**ATLANTIC COAST PIPELINE, LLC  
ATLANTIC COAST PIPELINE**

**DOMINION TRANSMISSION, INC.  
SUPPLY HEADER PROJECT**

**Revised Site Specific Geohazard Mitigation Design Drawings**

Date: 22 December, 2016  
To: Colin Olness, Dominion  
Copies to: Tony Rice, Geosyntec Seattle  
From: Logan Brant, Geosyntec Houston  
Subject: Revision C Updates to Site Specific Geohazard Mitigation Design Drawings  
MNF and GWNF Sites - Atlantic Coast Pipeline  
Geosyntec Project: TXG0007 / 013 / 1210

TITLE:	GEOHAZARD MITIGATION SITE SPECIFIC DESIGN PLAN AND PROFILE A-A'		
PROJECT:	ATLANTIC COAST PIPELINE, REV 11a		
SITE:	SITE SPECIFIC DESIGN MP 73.20 TO 73.50 (AP-1)

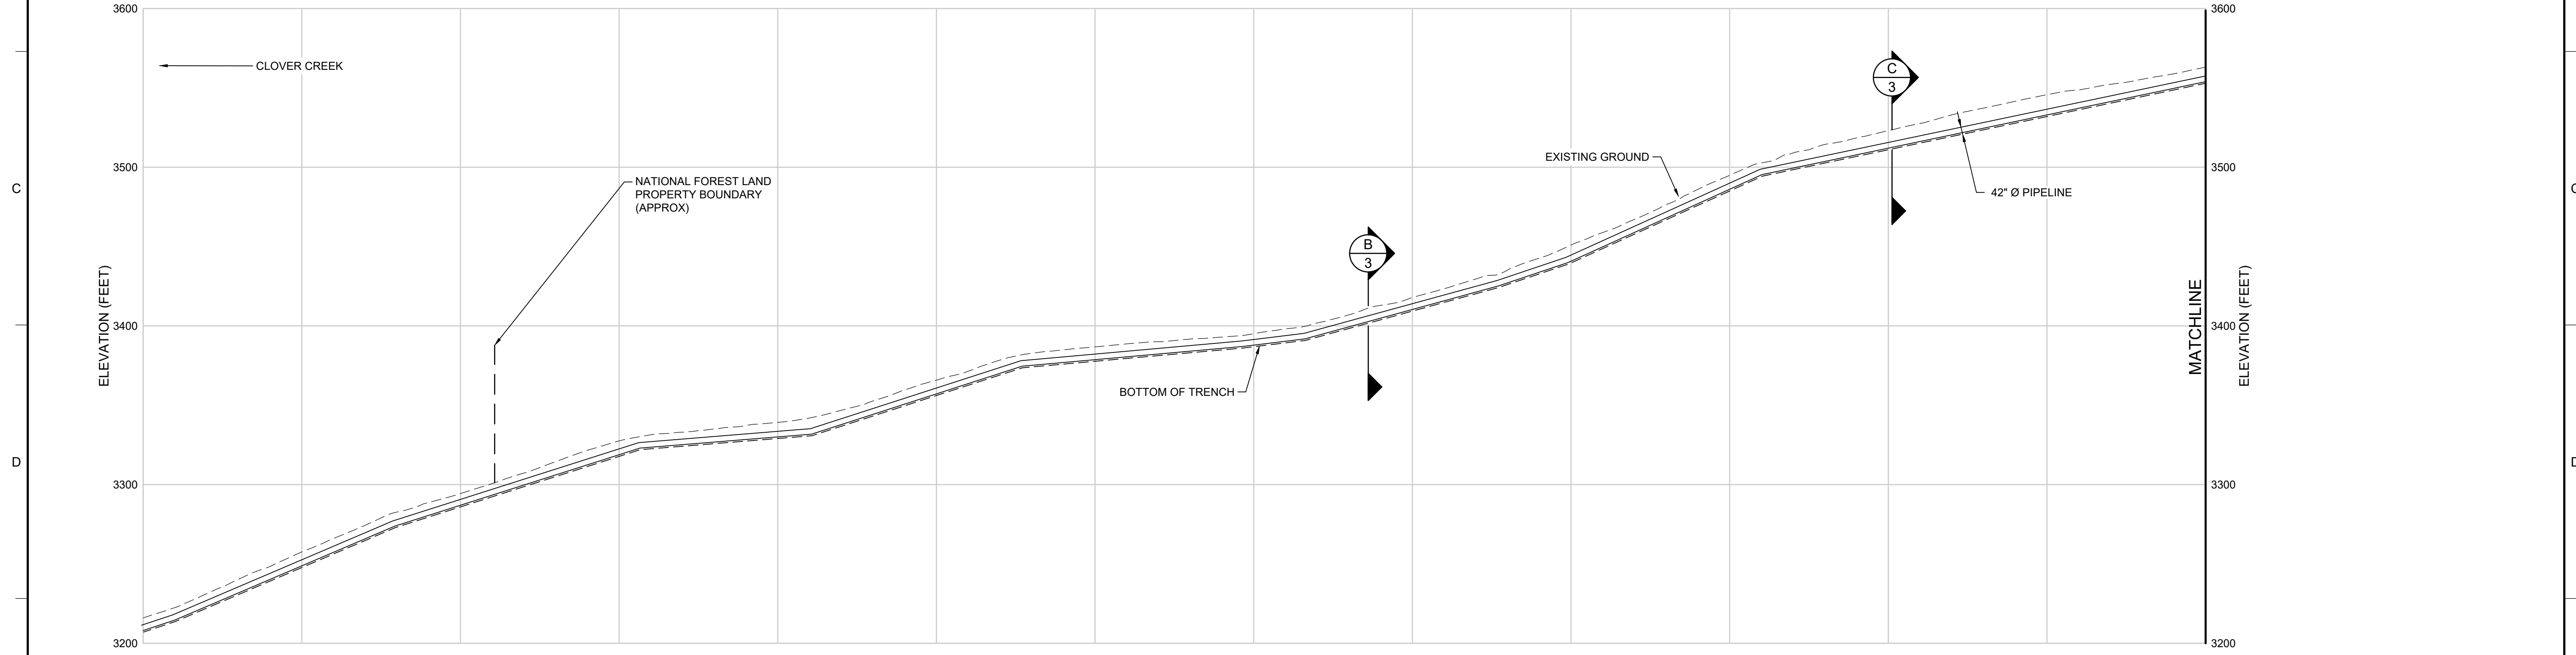
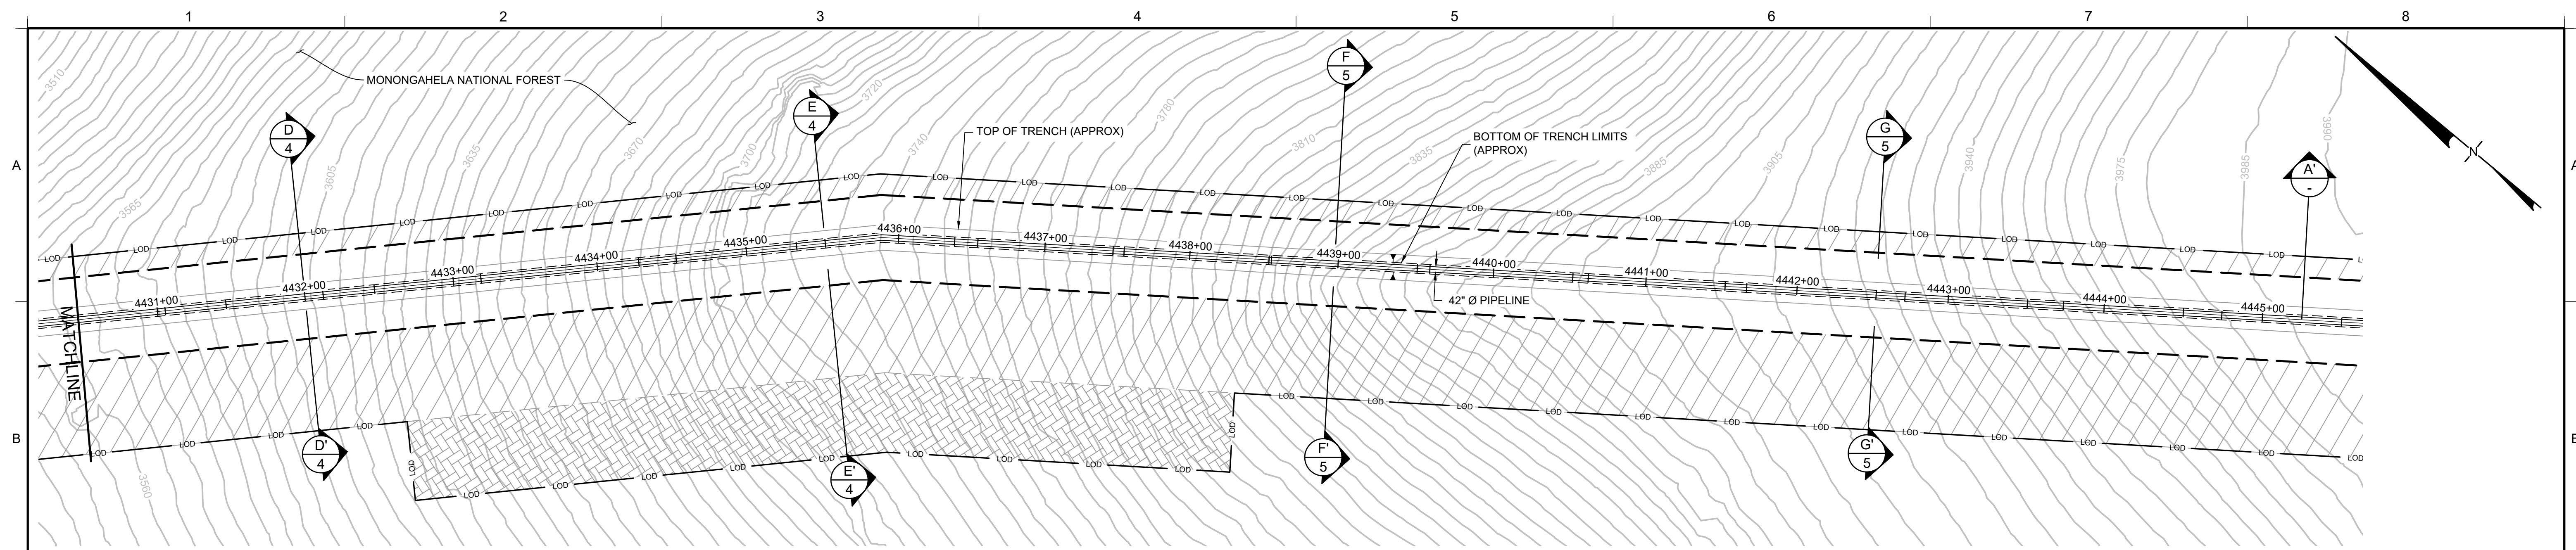
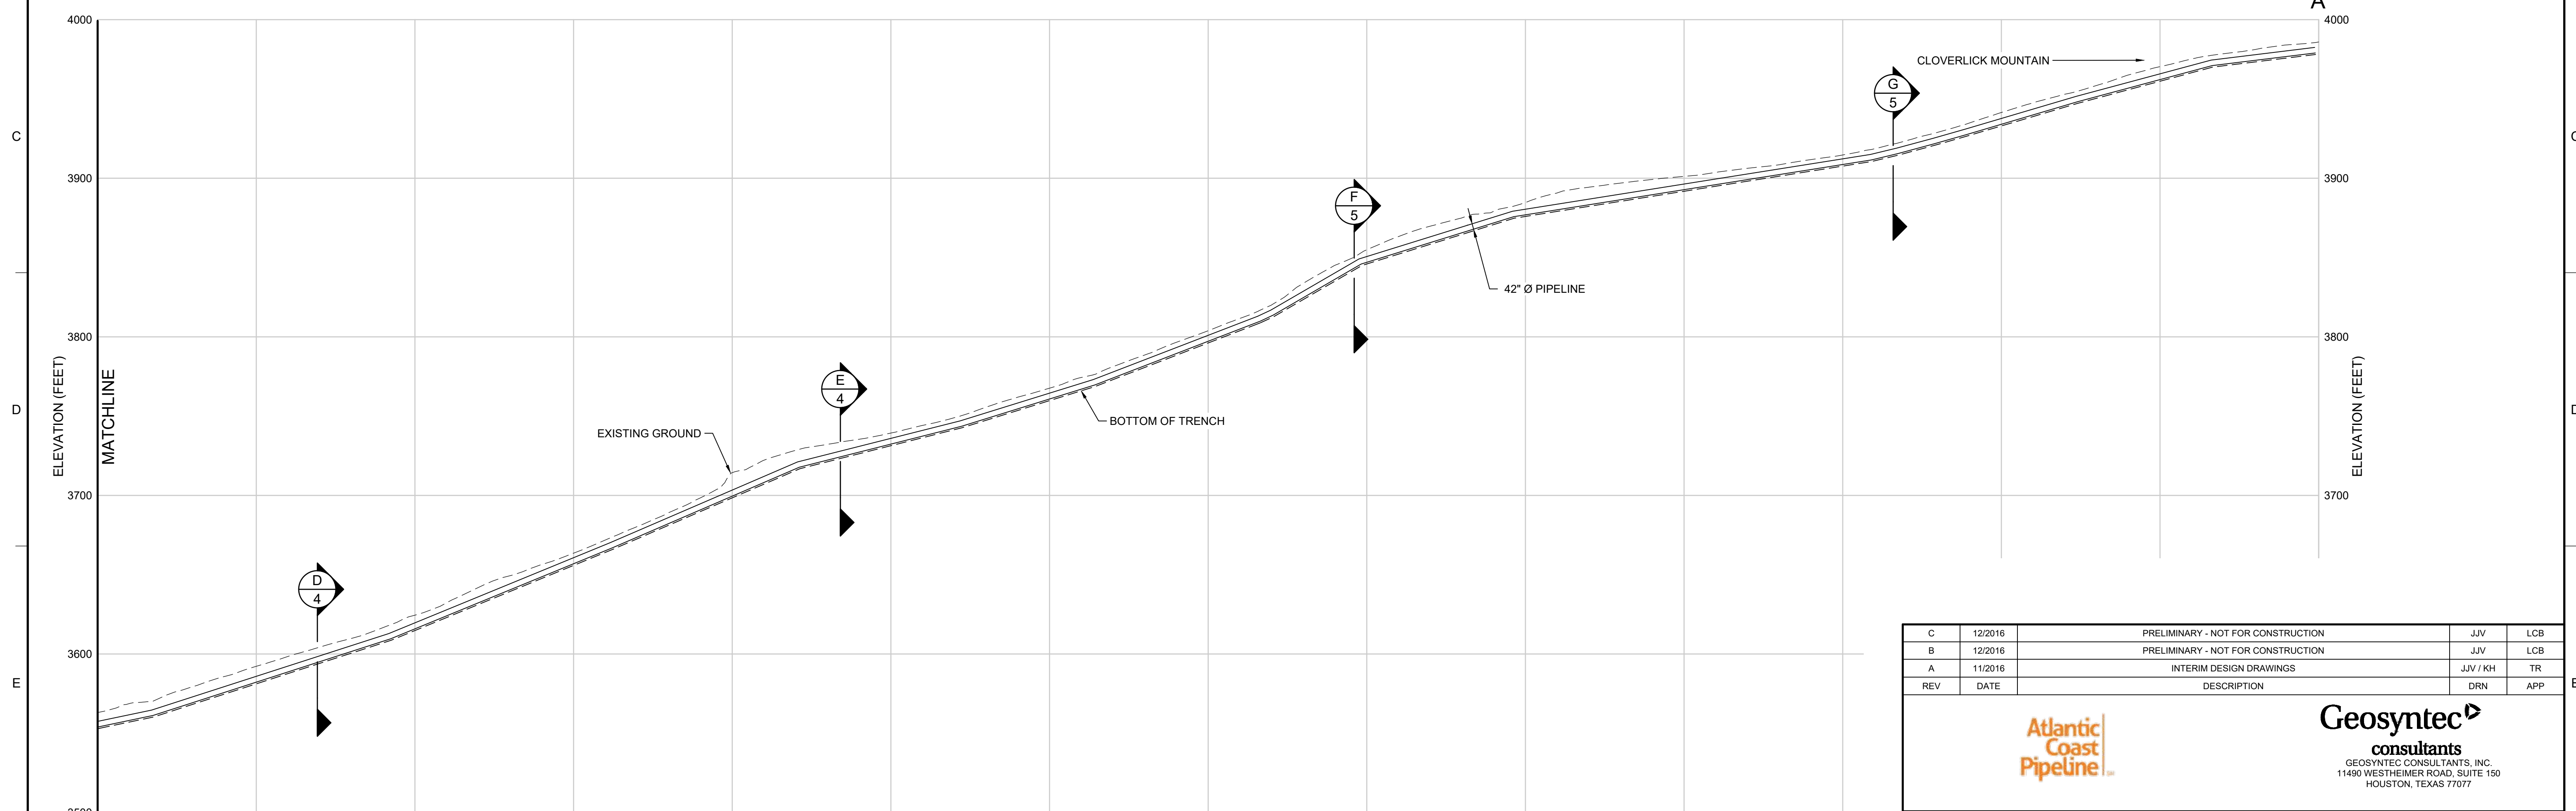
ACP AP-1 MP 73.20 to 73.50 – Plan and Profile A-A’:

- Scales of Plan and Profile A-A’ doubled from 1”=200’ (11x17) to 1”=100’ (11x17), in order to show the slopes in greater detail. This change required expanding the plan and profile to two drawings, with a matchline cut approximately mid-way on the slope.
- Revision C line added to the revision block.

Tom Collins indicated that that more detail was required for the profile at the MNF site in order for the Forest Service review. The revised drawing set presents at an enlarged scale, with the profile on two sheets instead of one.
